CROSS SECTION A-A'

COSON RESIDENCE
 MERCER ISLAND, WASHINGTON

FIGURE **3**

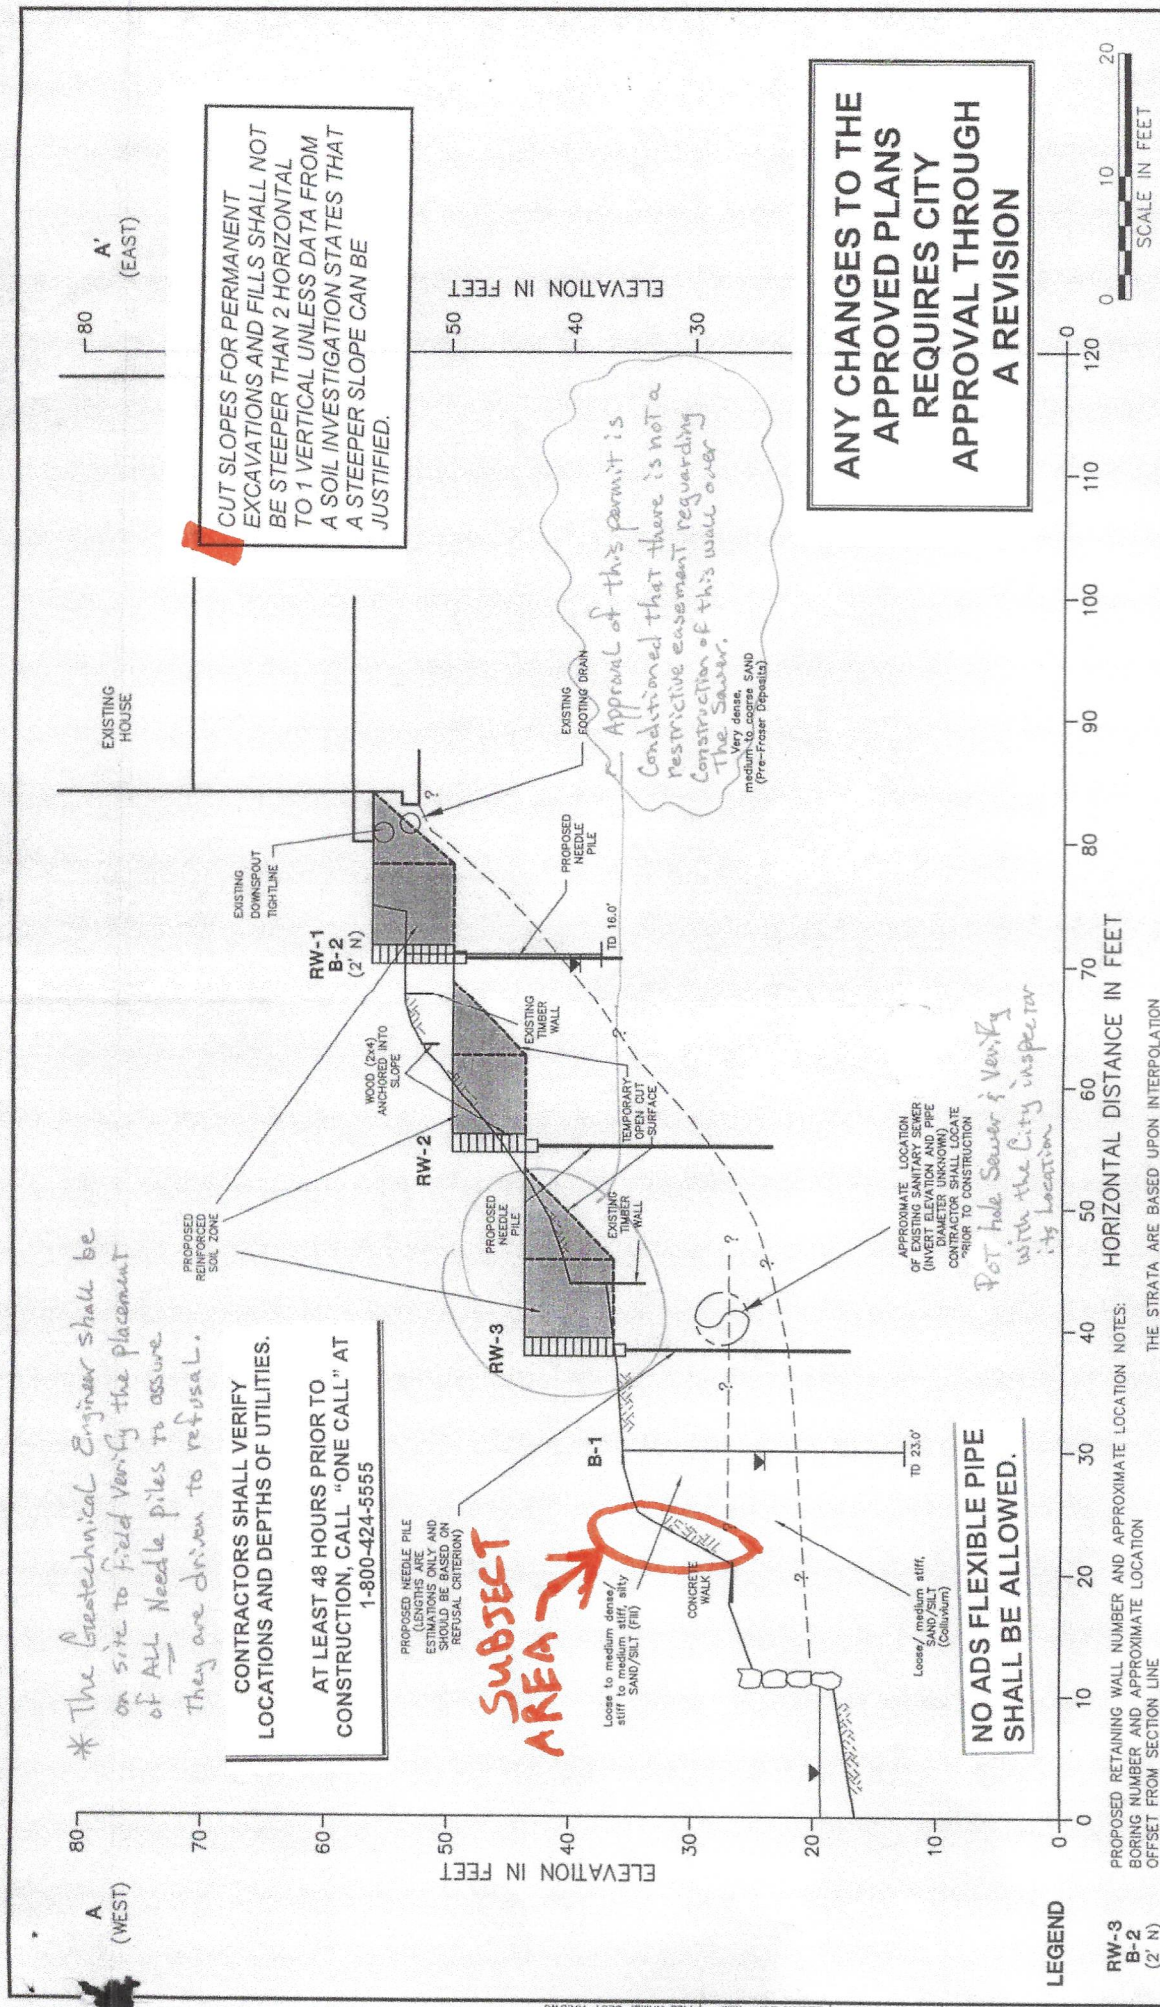
* The Geotechnical Engineer shall be on site to field verify the placement of ALL needle piles to assure they are driven to refusal.

NO ADS FLEXIBLE PIPE SHALL BE ALLOWED.

Pot hole Sewer & verify its location with the City inspector

Approval of this permit is conditioned that there is not a restrictive easement regarding construction of this wall over The Sewer. (medium to dense, SAND (Pre-Fraser Deposits))

ANY CHANGES TO THE APPROVED PLANS REQUIRES CITY APPROVAL THROUGH A REVISION
